SUBMITTAL TO THE BOARD OF SUPERVISORS
COUNTY OF RIVERSIDE, STATE OF CALIFORNIA

SUBJECT: TRANSPORTATION AND LAND MANAGEMENT AGENCY/TRANSPORTATION:
Approve Contract Change Order Nos. 11 and 12 – Between the County of Riverside and Granite Construction Company for the Construction of Jurupa Road/Union Pacific Railroad Grade Separation Project, District 2. [\$205,000 Total Cost – State Funds 100%]

Contract Change Order No. 012

JURUPA ROAD/
UNION PACIFIC RAILROAD
GRADE SEPARATION
CDD #012
ATTACHMENT A
SHEET 1 OF 13

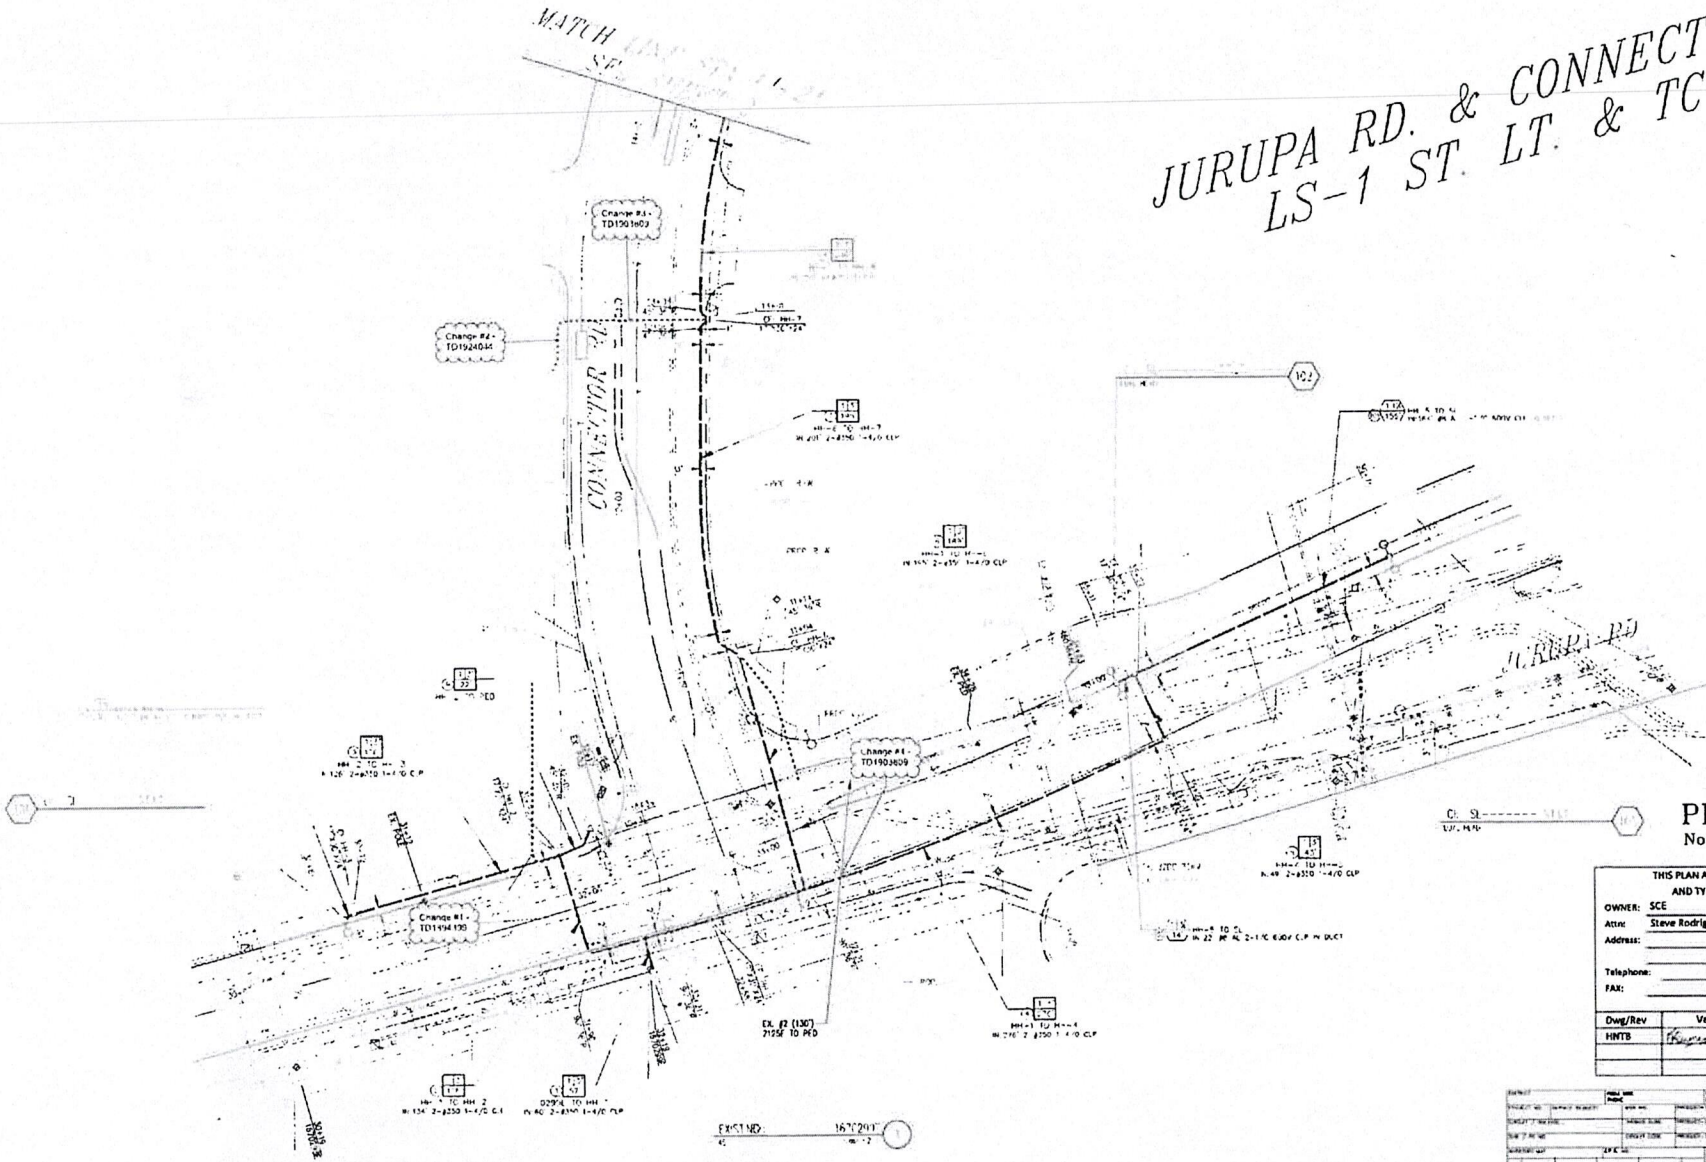
As directed by the Engineer and in accordance with Section 9-1.04, "Force Account," of the Standard Specifications, compensate the contractor for the costs to be incurred for the additional Southern California Edison (SCE) work not indicated on the original contract documents. The contractor shall install additional conduits to the SCE runs and services to meet project demands per the attached drawings - see Attachment A.

Conduits and services will be extended and/or added at:

- TD #1811683: Pump Station
- TD #1894399: Corner of Connector Rd & Jurupa Rd
- TD #1903809: Connector Rd
- TD #1919827: Northeast corner of Jurupa Rd and Pedley Rd
- TD #1924044: Miller Driveway & Connector Rd
- TD #1967394: Southwest corner of Van Buren Blvd & Connector Rd
- TD #1967548: Northwest corner of Felspar St & Jurupa Rd
- TD #2053119: Facilities behind Stater Bros

As determined by the Engineer, provide all additional labor, material, equipment, tools, and incidentals to add additional conduits to the SCE runs and the additional services per the final drawings, to remove and haul any temporary patching, and to prepare grading for paving. All work shall be done in accordance with the contract documents.

JURUPA ROAD/
UNION PACIFIC RAILROAD
GRADE SEPARATION
CCO #012
ATTACHMENT A
SHEET 10 OF 13

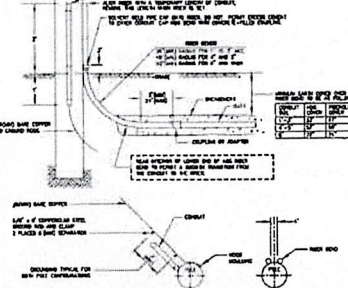
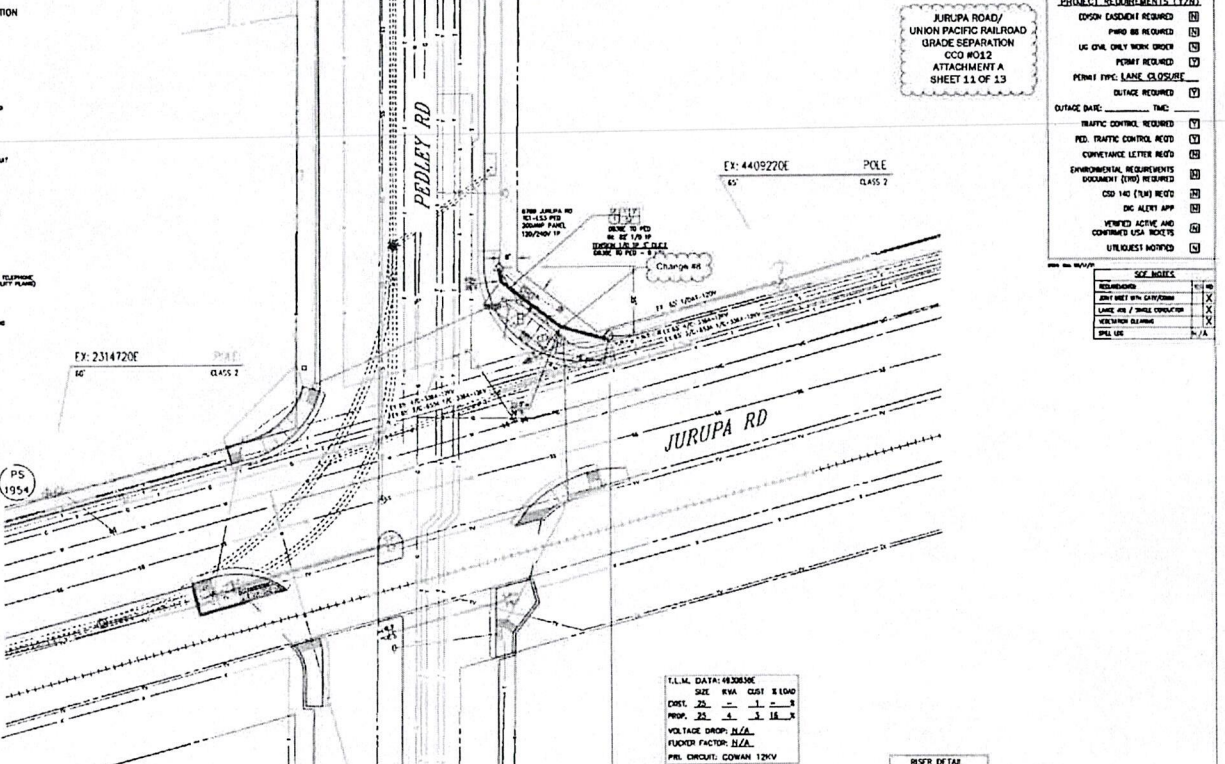
GRANITE (RFI)

1. The radius of the conduit sweeps, - RADIUS SWEEPS FROM XX5527722 TO TRANSFORMER PAD ARE 12.5R. FROM TRANSFORMER PAD TO PANEL ARE 48" R.
2. Is the schedule of the conduit sch 40 or sch, 80? - EVERYTHING WILL BE SCH 40.
3. Is encasement necessary? If so, which encasement is required. - ONLY ENCASEMENT REQUIRED IS WHERE THERE WILL BE 3 CONDUITS. THIS PROJECT YOU WILL HAVE THE 1-5" CONDUIT OVERLAPPING THE 2-3" CONDUITS THAT WILL BE INSTALLED ON TO1967548. (3-CONDUITS = SEMI ENCASED)
